# UNITED STATES PATENT AND TRADEMARK OFFICE

APPLICATION NO.	FILING DATE	FIRST NAMED INVENTOR	ATTORNEY DOCKET NO.	CONFIRMATION NO.
10/733,160	12/10/2003	Robert L. Doubler	75028-307910	5934

**Office Action Summary**

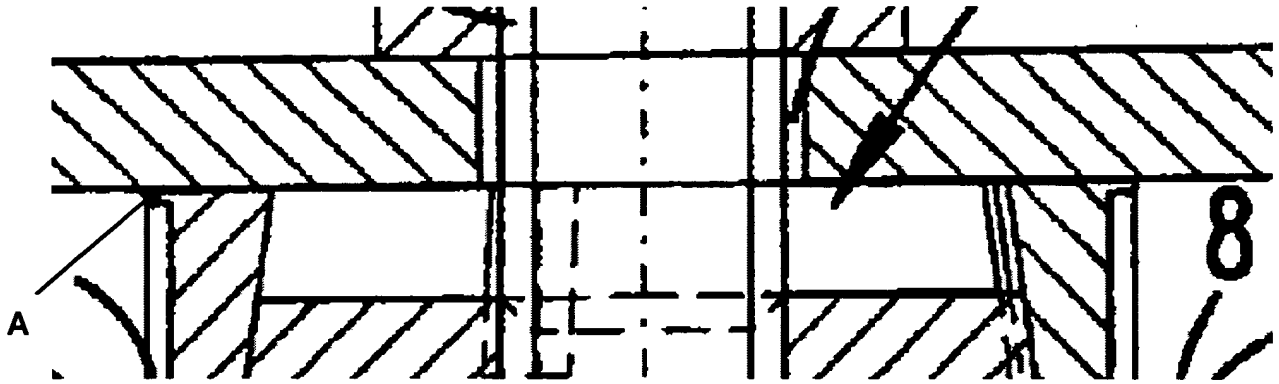
surface, the engaging surface tapering inwardly from about the first end and extending toward a second end, the second end defining a clamping surface **A** (clamping surface **A** clamps against object **3**; thus defining a clamping surface; Figure 6 reprinted below with annotations) adapted to engage the object;

wherein the body member outer surface and the gripping surface are configured and positionable relative to each other to from a compressive contact with each other to linearly shift relative to each other under the compressive contact to cause an increased compression between the clamping surface and the object when the body member is circumferentially expanded from an unloaded state (body member **7** is capable of

linearly shifting relative to gripping surface 4 under compressive contact due tightening bolt 15; Figures 2 and 6).

As to claim 23, Krüger et al. disclose a fastener wherein the machinery component **2,4** comprises a portion (bolt **15**) adapted to support the object **3** to be fastened against the clamping end **A** (Figure 6).

As to claim 24, Krüger et al. disclose a fastener wherein both of the outer surface of the expander member **14** and the inner surface of the expandable portion **16** of the body member **7** has a portion at an angle from the longitudinal axis and adapted to remain in contact with the other one of the outer surface of the expander member and the inner surface of the expandable portion of the body member during the longitudinal advancement of the expander member (Figure 6).

As to claim 25, Krüger et al. disclose a fastener wherein the expandable portion **16** of the body member **7** has a portion at an angle from the longitudinal axis and adapted to remain in contact with the gripping surface **4** during the radial expansion of the expandable portion of the body member (Figure 6).

As to claim 26, Krüger et al. disclose a fastener wherein the outer surface of the expander member **14** and the inner surface of the expandable portion **16** of the body member **7** form a self-locking taper (Figures 2 and 6).

Examiner disagrees. As to claims 1 and 22, Krüger et al. disclose a fastener system wherein the body member **7** outer surface and the gripping surface **4** are configured and positionable relative to each other to from a compressive contact with each other to linearly shift relative to each other under the compressive contact to cause an increased compression between the clamping surface **A** and the object **3** when the body member is circumferentially expanded from an unloaded state (body member **7** is capable of linearly shifting relative to gripping surface **4** under compressive contact due tightening bolt **15**; Figures 2 and 6).
